Angio to Cath. Lab Renovation

ADDENDUM #6

**TCMC Angio to Cath Lab Renovation**

**BID ADDENDUM NO. 6**

M201

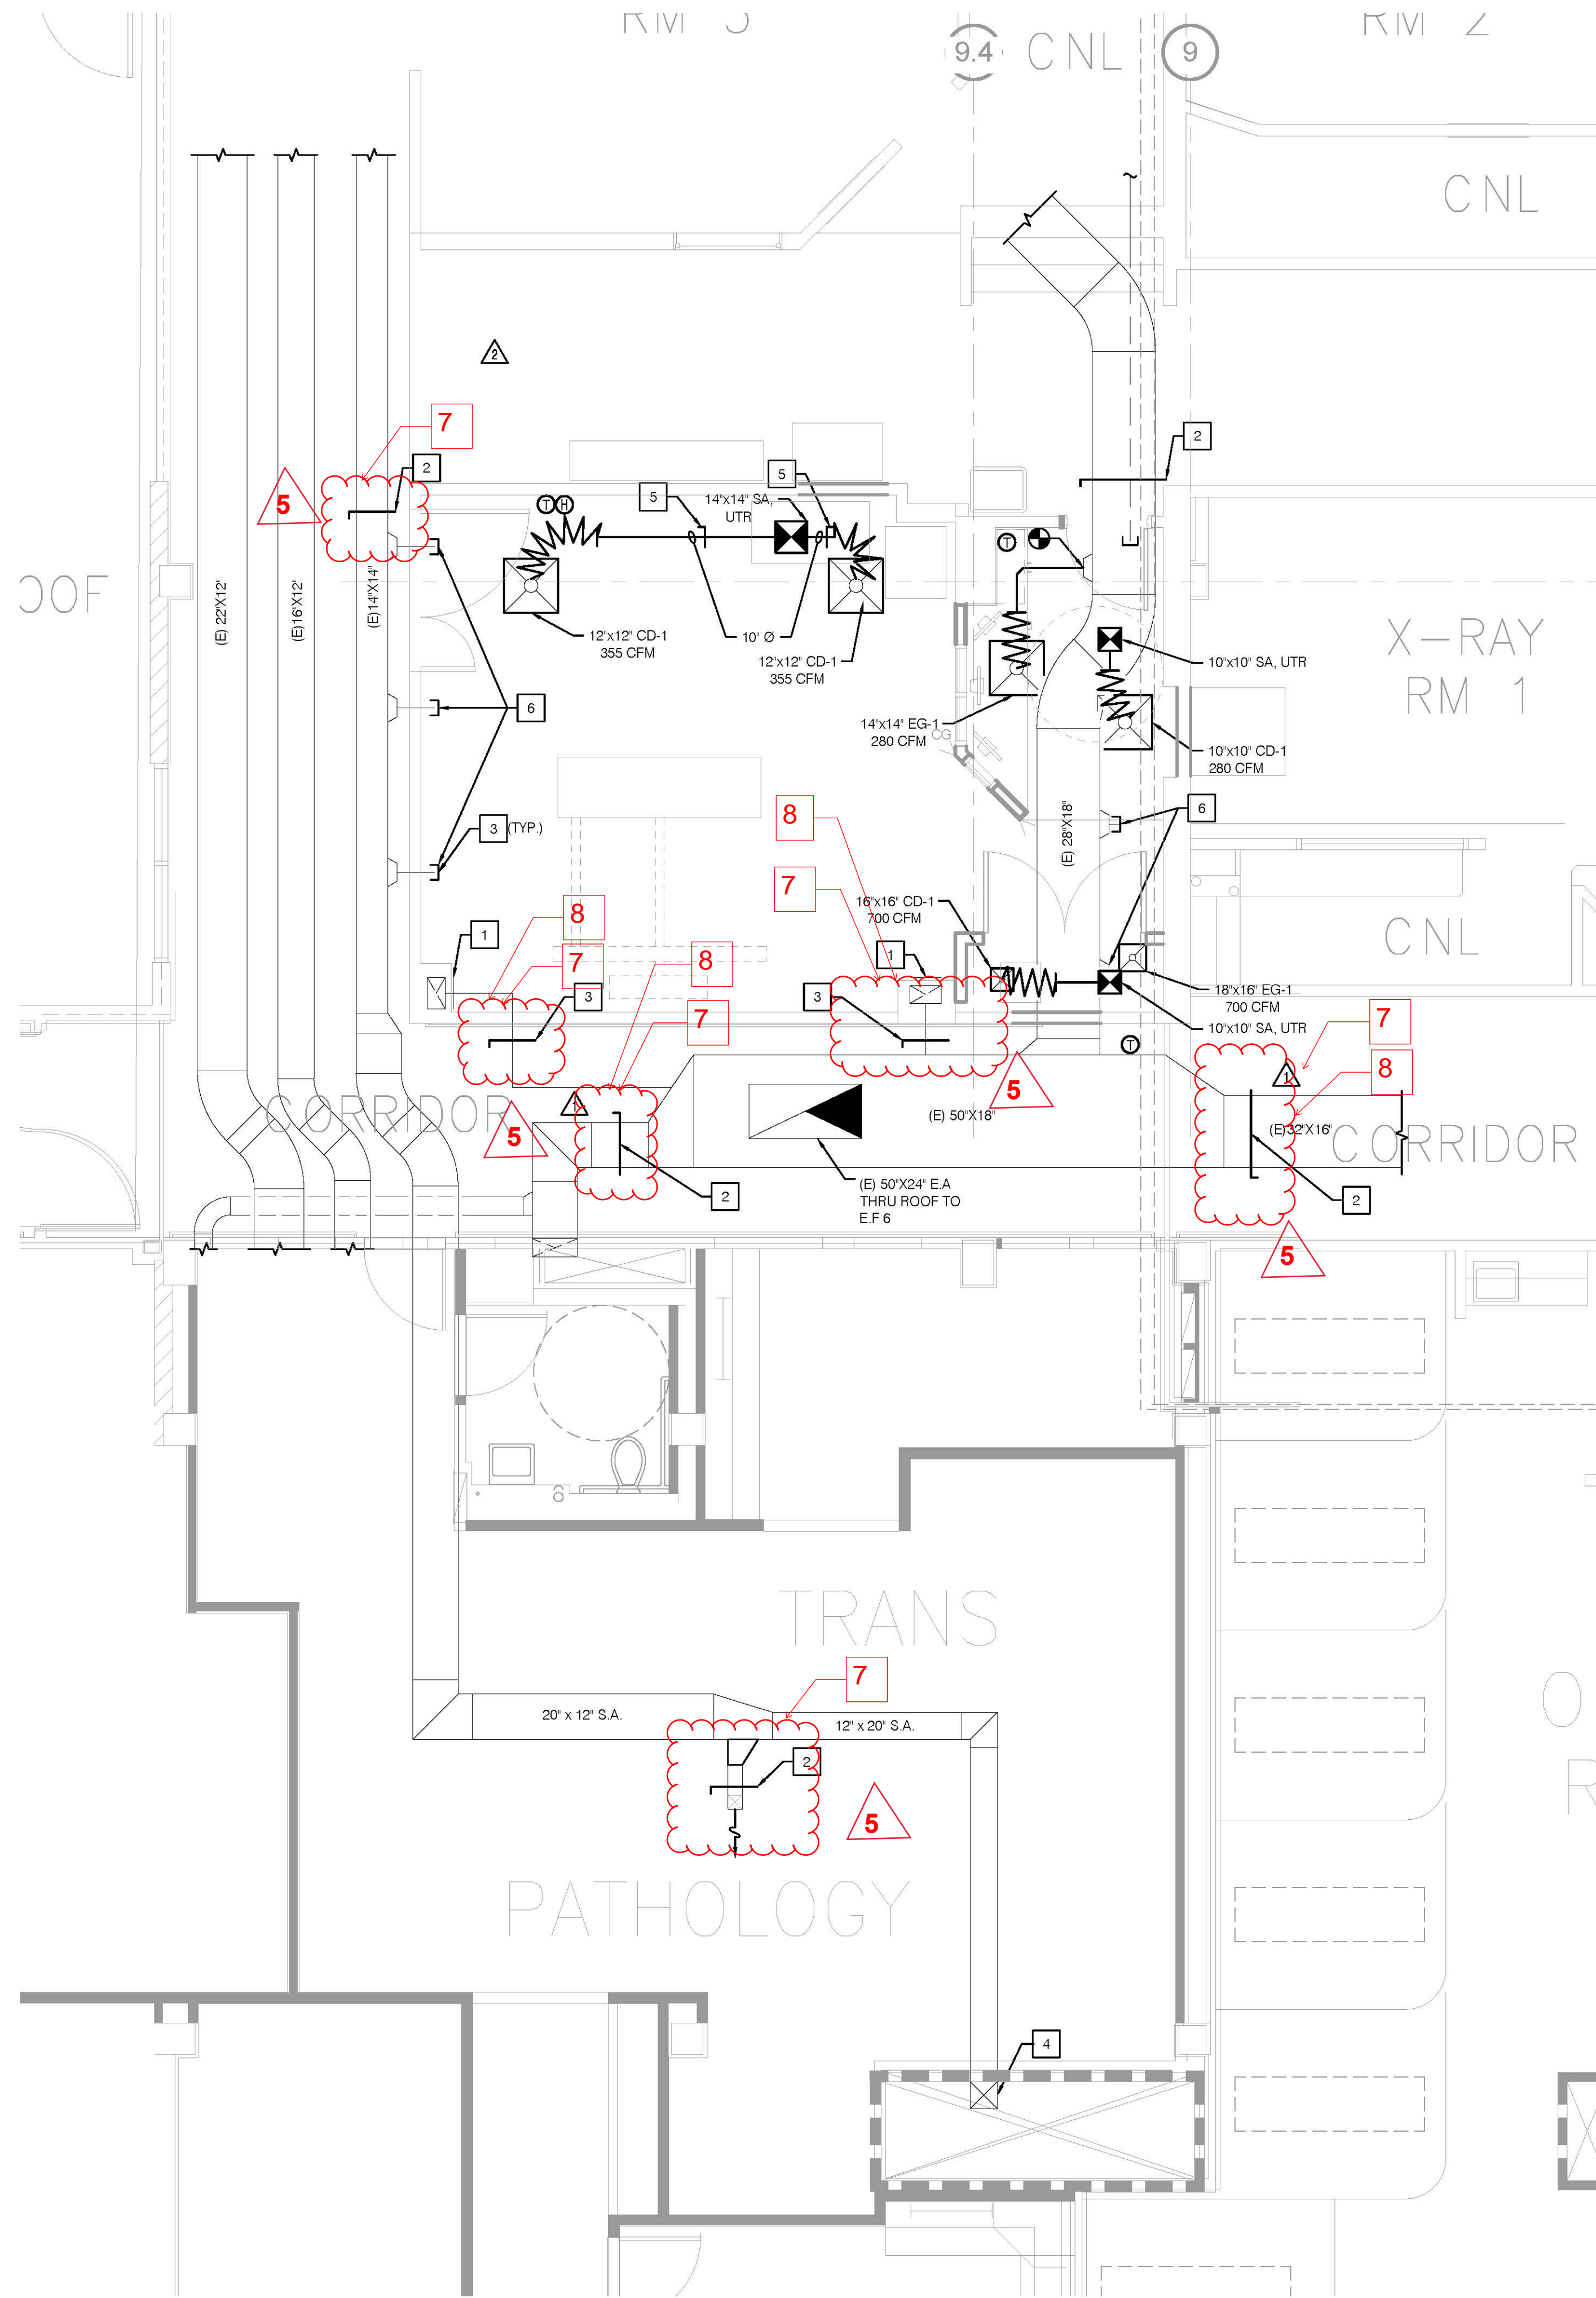
Item No. 1 - Sheet M201:  
Delta 5 Revision Dated 1/23/18.  
Notes added:

7. Exact location of damper shall be verified/determined by the contractor.
8. Contractor to determine suitable location for damper outside of corridor.

7 Exact location of damper shall be verified/determined by the contractor.

8 Contractor to determine suitable location for damper outside of the corridor.

SHEET NUMBER:  
**M202**

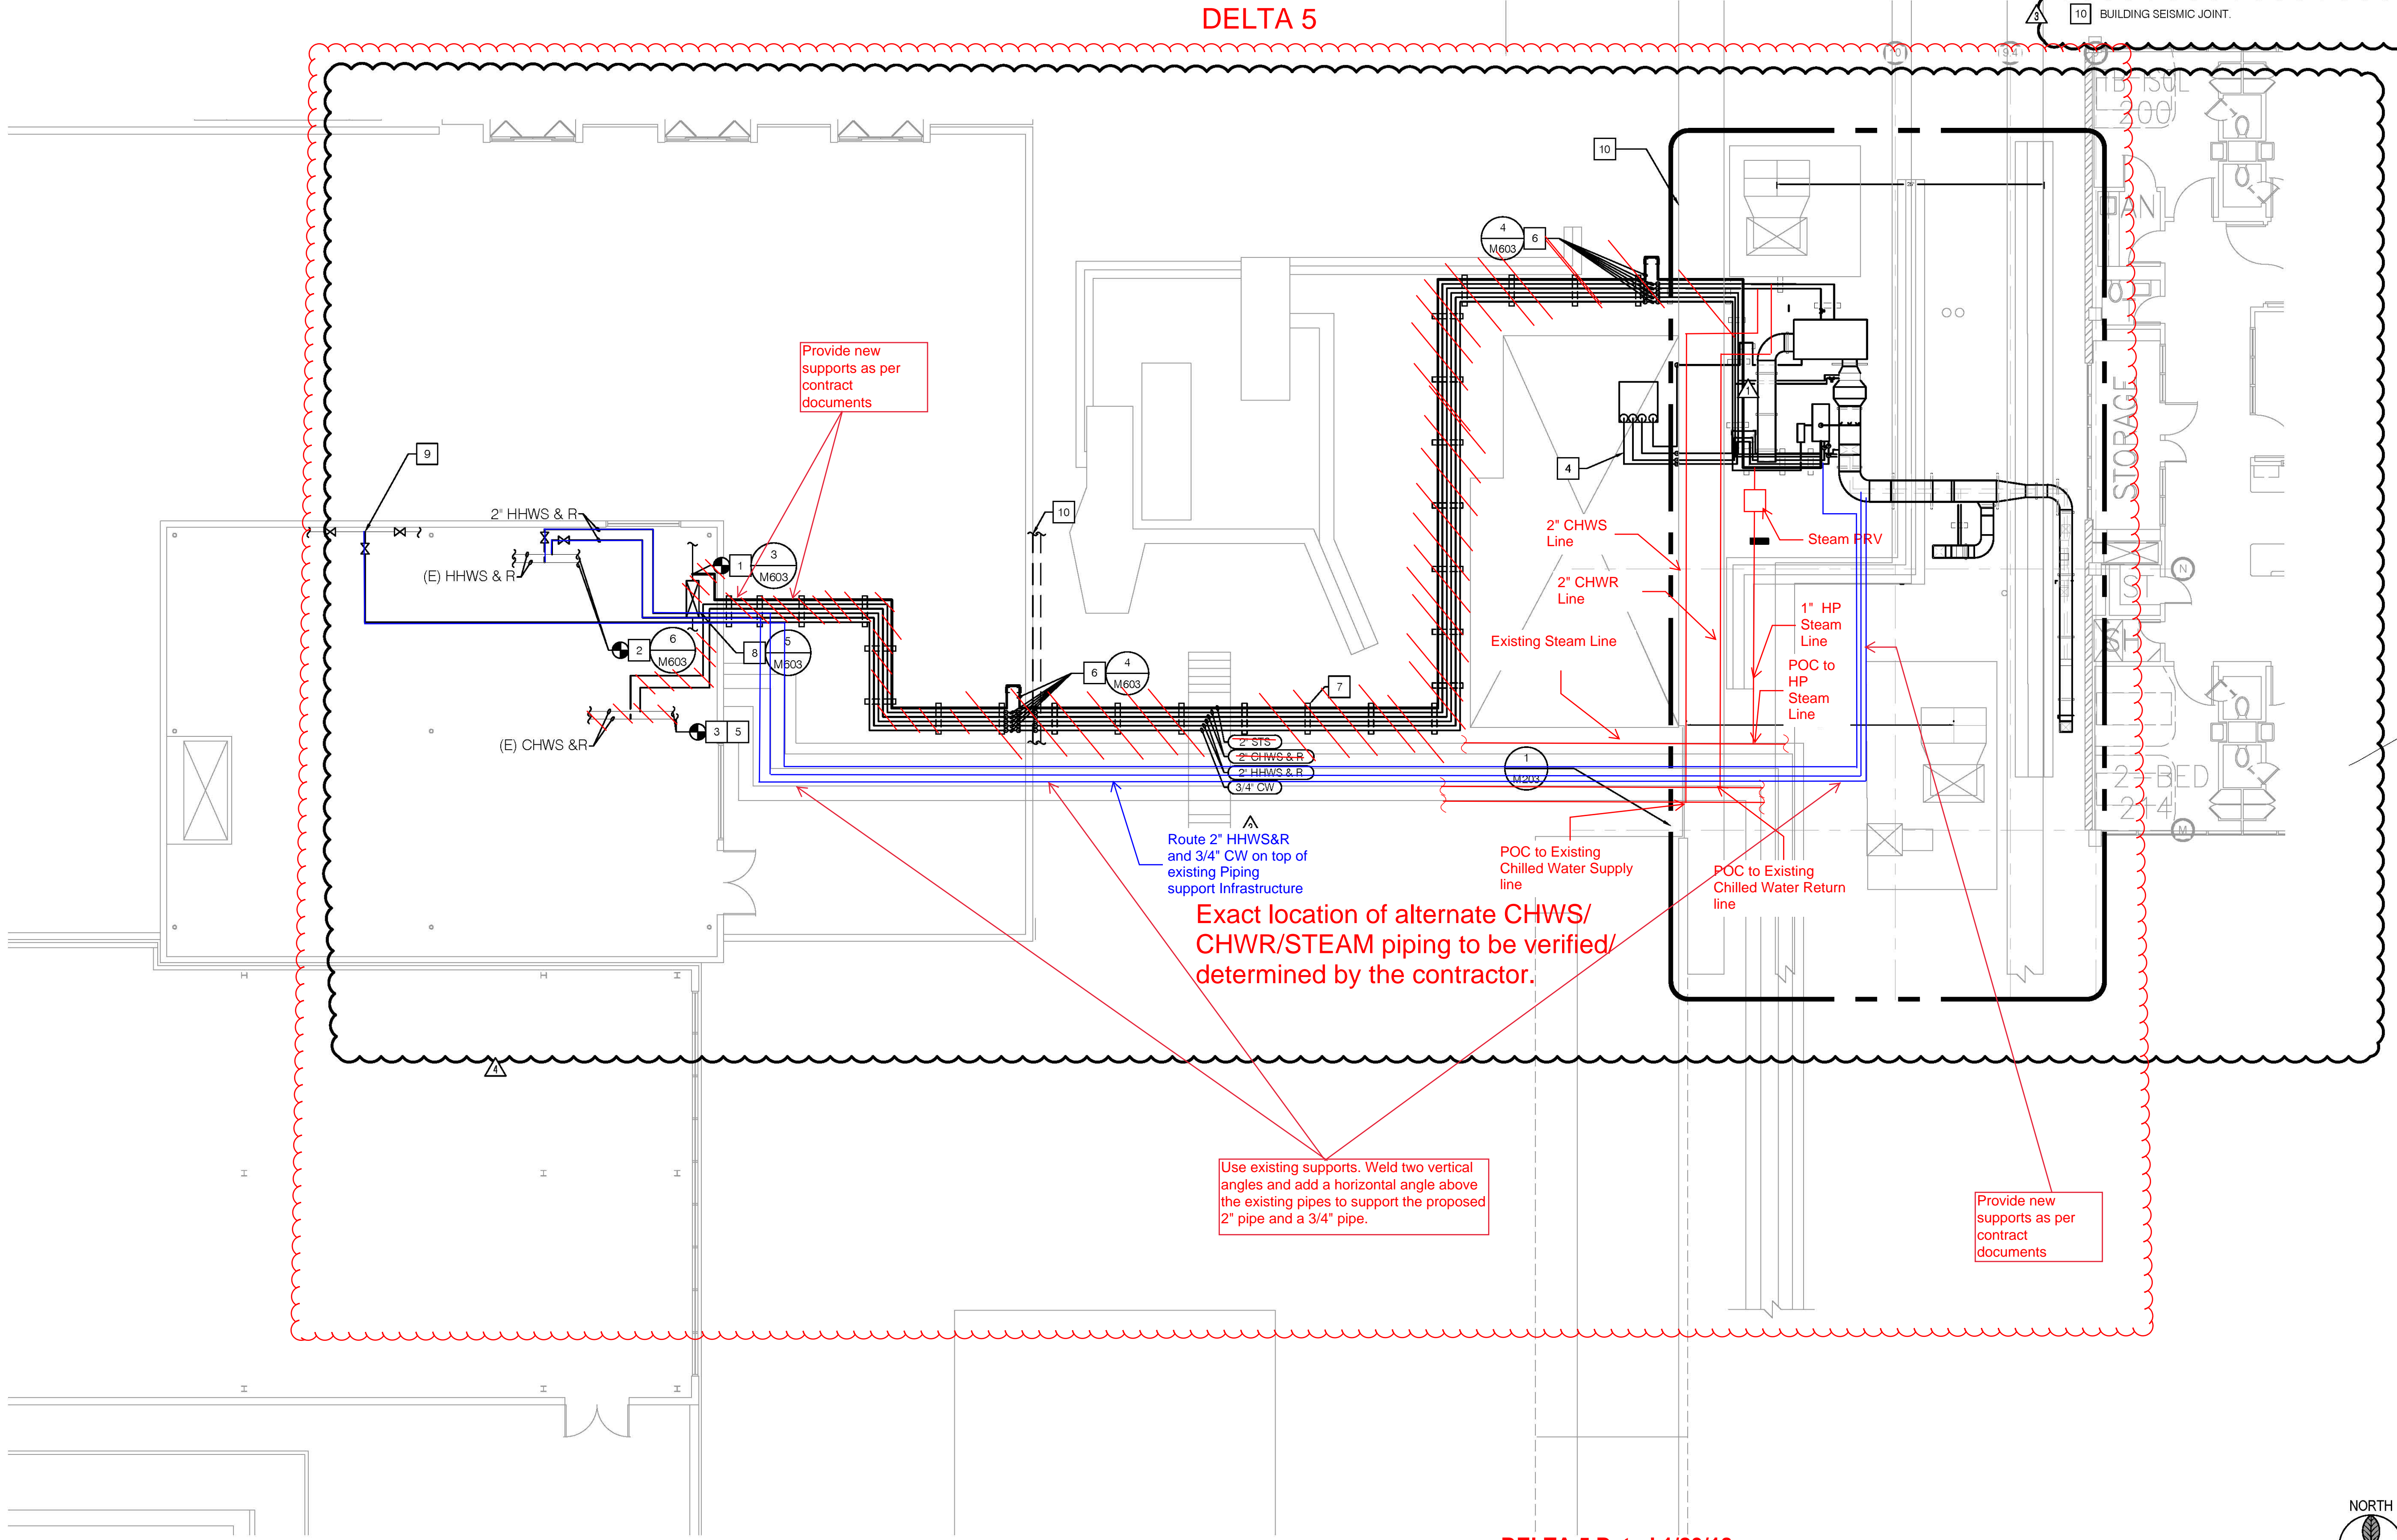
Item No. 2 - Sheet M202:  
Delta 5 Revision Dated 1/23/18.  
See attached revised drawing. Modify piping layout and point of connection locations. Refer to ALTERNATE 002 in Addendum No. 002.

# M203

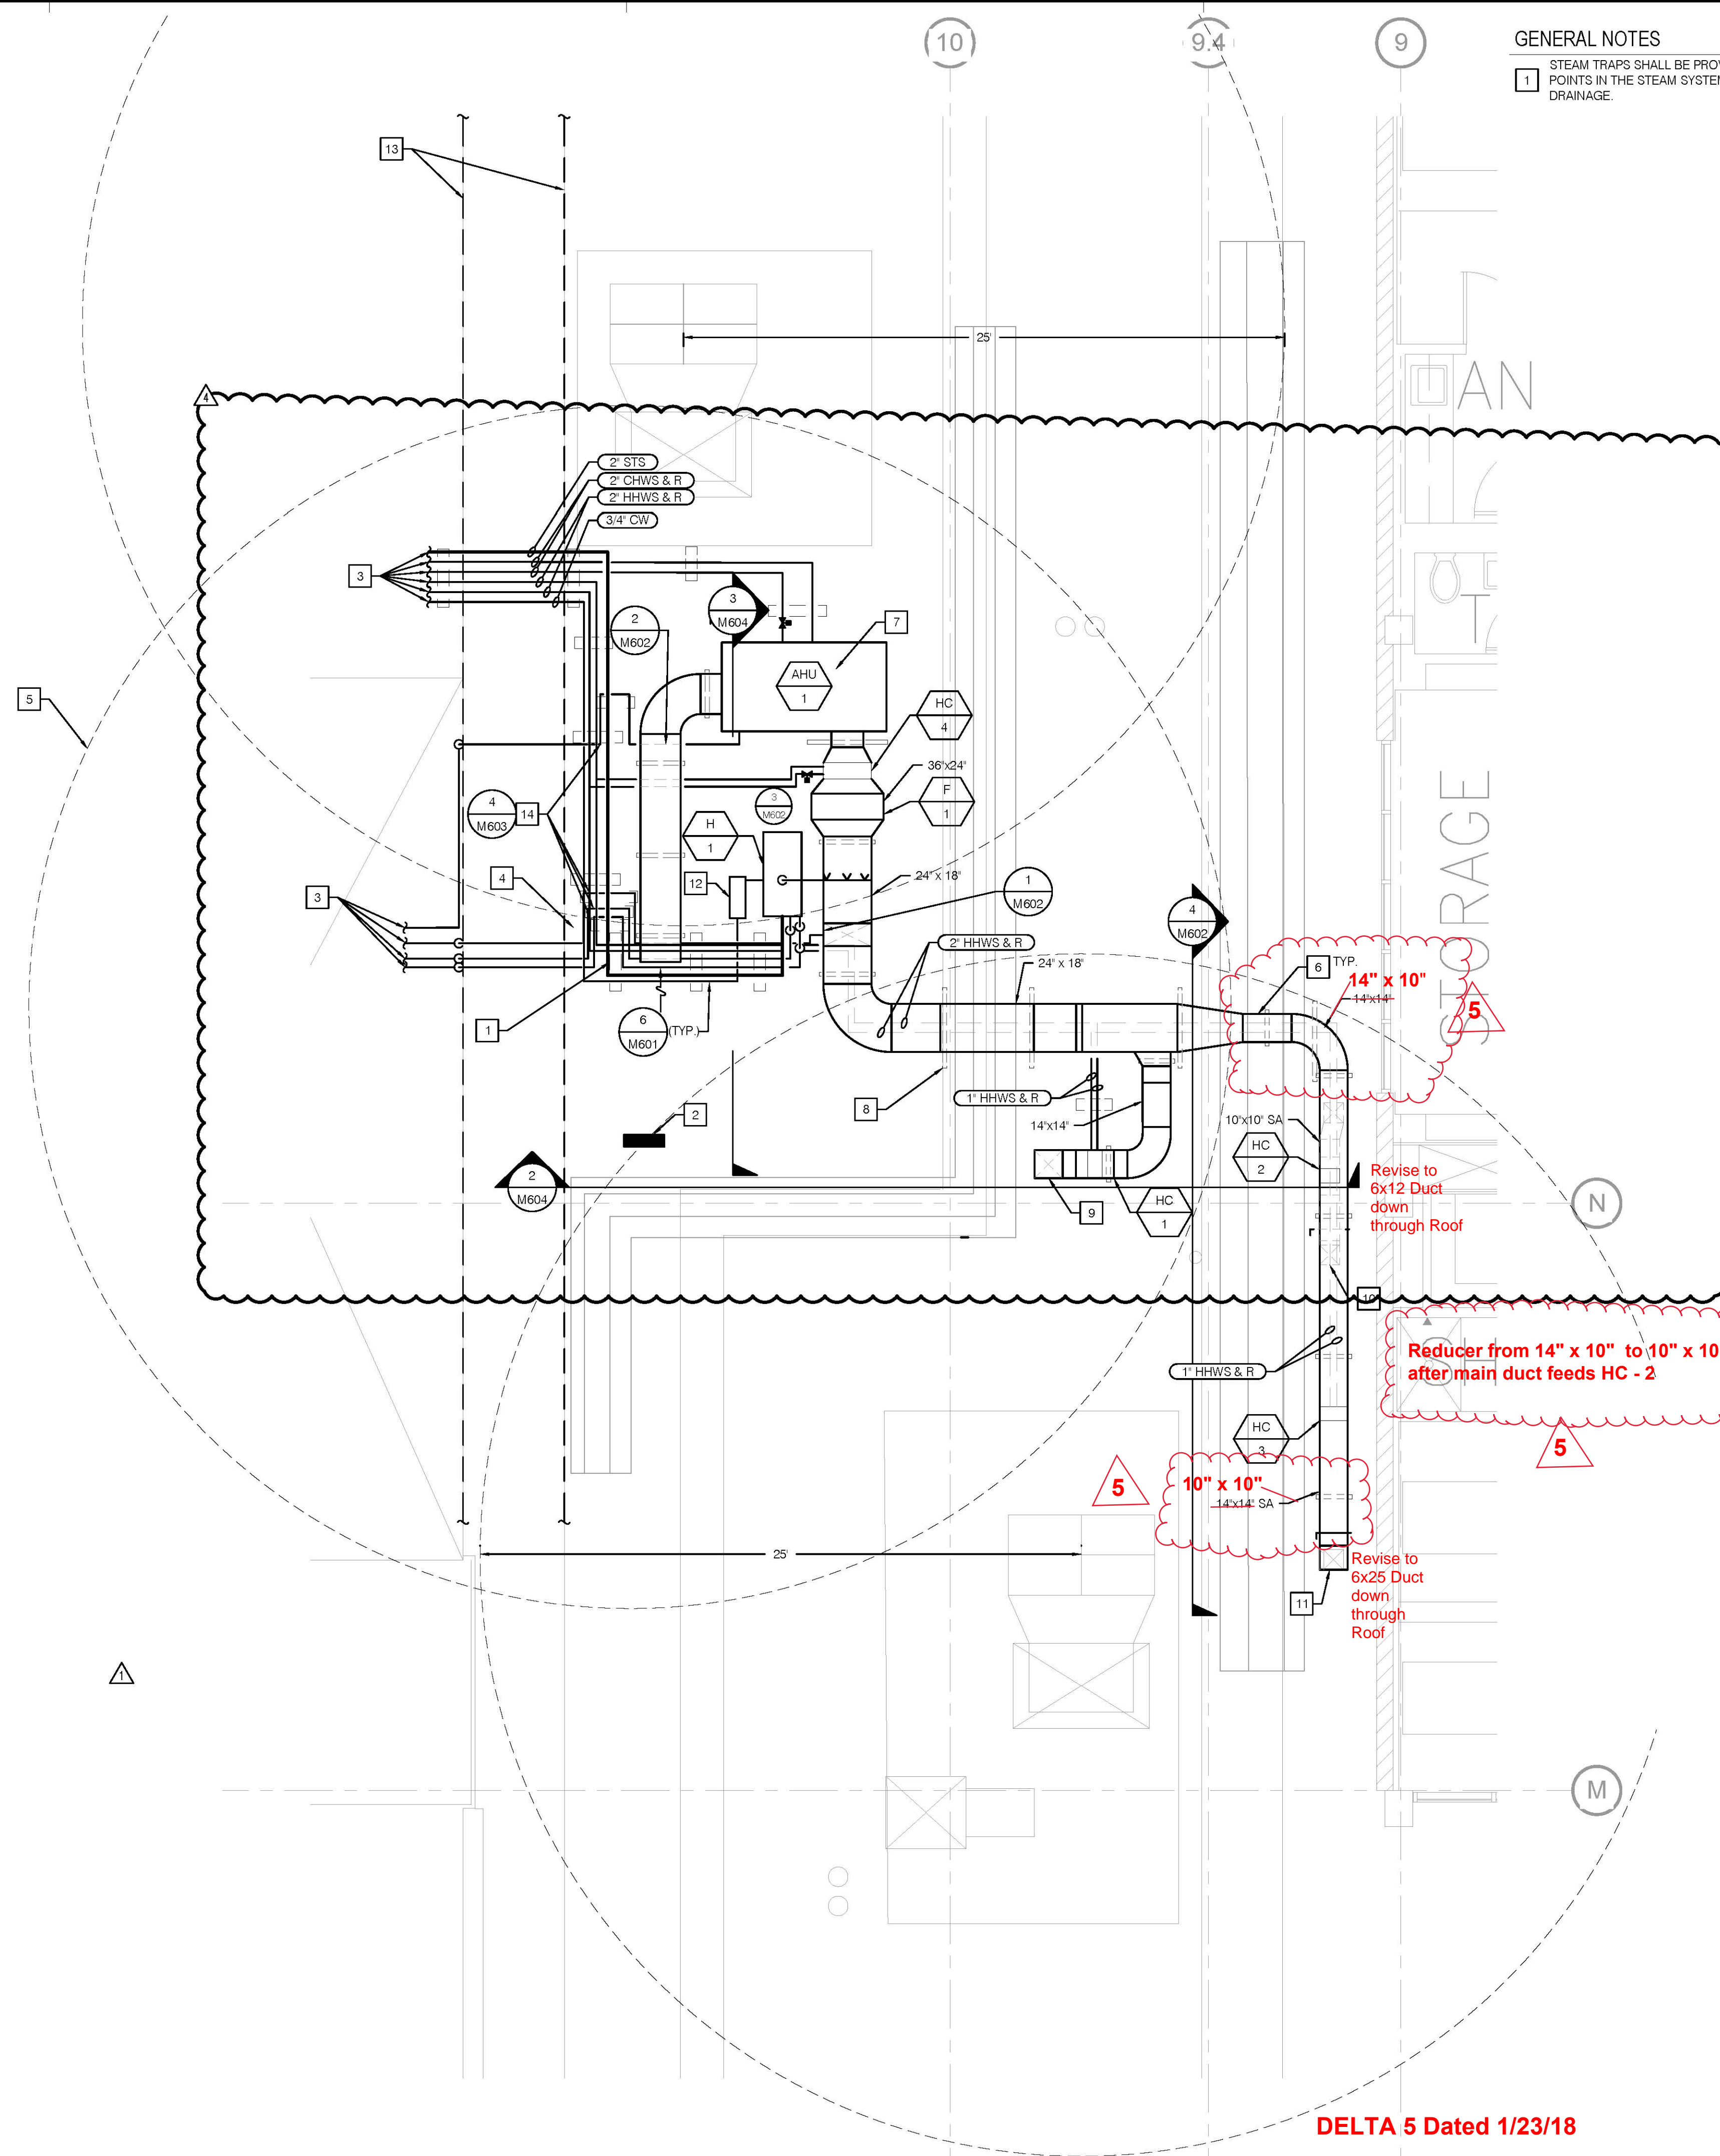
Item No. 3 - Sheet M-203:  
Delta 5 Revision Dated 1/23/18.  
Revise Roof Penetrations adjacent to column line 9.
